# National Committee on Uniform Traffic Control Devices

## NCUTCD Proposal for Changes to the Manual on Uniform Traffic Control Devices

**TECHNICAL COMMITTEE:** Regulatory and Warning Signs Committee  
**ITEM NUMBER:** 19A-RW-02  
**TOPIC:** HILL BLOCKS VIEW Sign  
**ORIGIN OF REQUEST:** RWSTC Discussions  
Task Force: Dan Paddick (Chair) Randy McCourt, Herman Hill, Dan Waddle, James Sullivan, Jeff Wolfe, Jim Pline  
**AFFECTED SECTIONS OF MUTCD:** Section 2C.18

### 233 234 **Section 2C.18 HILL BLOCKS VIEW Sign (W7-6)**

W7-6

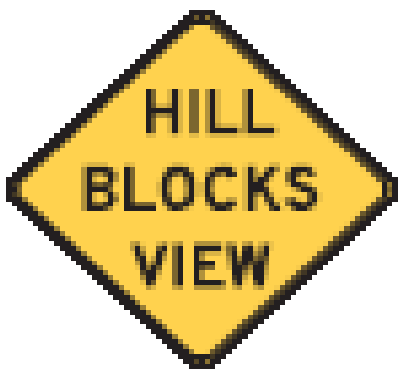
203 Canadian study. The consensus was that the LIMITED VISIBILITY plaque should be replaced  
204 with a HILL BLOCKS VIEW plaque or an OBSTRUCTED VIEW plaque. However, Sponsor  
205 comments indicated that there was considerable opposition to the RWSTC consensus. Upon  
206 review of the Sponsor comments it was decided to retain the HILL BLOCKS VIEW sign.

- 213 1. Retain the existing HILL BLOCKS VIEW (W7-6) sign.
- 214 2. Downgrade the use of the Advisory Speed plaque to an Option from a Guidance. Section  
215 2C.08 already allows this option so no new text is needed. The original NYSDOT  
216 study found that the use of the Advisory Speed plaque was counterproductive.  
217 Approach speeds actually increased when the plaque was used. Since Section 2C.08  
218 already allows the optional use of an Advisory Speed plaque with any warning sign  
219 delete any mention of the Advisory Speed plaque in this Section.
- 220 3. Add a Guidance paragraph stating that the sign for specific potential hazard beyond the  
221 crest (i.e. Curve Warning, Intersection, STOP AHEAD, etc.) should be used rather  
222 than the general OBSTRUCTED VIEW sign.

243 01a A HILL BLOCKS VIEW (W7-6) sign (see Figure 2C-4) may be used on the approach to a  
244 crest vertical curve where the vertical curvature provides inadequate stopping sight distance at  
245 the posted speed limit.

247 01b When a vertical curve results in a sight distance obstruction to a specific beyond the crest of  
248 the vertical curve, the sign for the specific condition beyond the vertical crest should be used

249 rather than the HILL BLOCKS VIEW (W7-6) sign. Some examples are the Curve Warning W1  
250 series, Intersection W2 series, STOP AHEAD W3 series, RR Crossing W10 series,  
251 Crosswalk/Crossings W11 series, etc.  
252

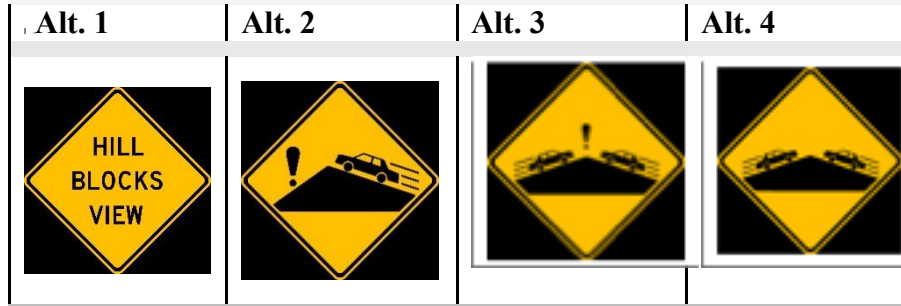
134 The following alternative blind hill warning signs were evaluated.

153  
 154 Next, participants were told the intended meaning of the blind hill warning sign. The four sign  
 155 alternatives were presented and the participants were asked to rank them in terms of perceived  
 156 effectiveness. When considering only the top choice indicated by the participants (Ranking = 1),  
 157 Alternative 1 was selected as the top choice by the majority of participants (65.5 percent). The  
 158 data helps support that the blind hill warning signs were usually preferred by the participants in  
 159 the following order: Alternative 1, Alternative 3, Alternative 2, Alternative 4.

165  
166 Alternate 1, the HILL BLOCKS VIEW sign had the best legibility distance. Alternate 3 had the  
167 had the third best legibility distance.

168  
169 Answers A and C in the first table identified a sight distance obstruction as being the problem.  
170 In eighty-six percent of the responses to Alternate 1 either A or C was chosen. This indicates that  
171 the responders got the message that there was a sight distance restriction. Alternate 3 was the  
172 next best with 62%. Alternate 4 had 40%. Alternate 1 was the best for comprehension and for  
173 legibility distance. Alternate 3 was second for understanding and had the third best legibility  
174 distance.

- 189 4. The Pooled Fund Study concluded that the HILL BLOCK VIEW sign had the best  
190 comprehension and legibility distance. The comprehension of the most effective symbol  
191 sign was 24% worse than the legend sign and its legibility distance was 14 % shorter.  
192 Symbol signs with a supplemental plaque were not considered.
